TECHNICAL BULLETIN

FA-A-0337-A

Precautions when Using Macro Type Function Blocks in GX Works3

Date of Issue
June 2021
Relevant Models
GX Works3

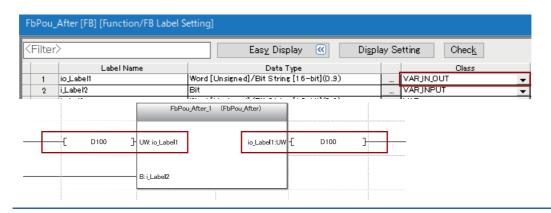
Change the transfer destination of output argument data of a function block from a device to a global label to which the device is assigned.

Global label setting after change
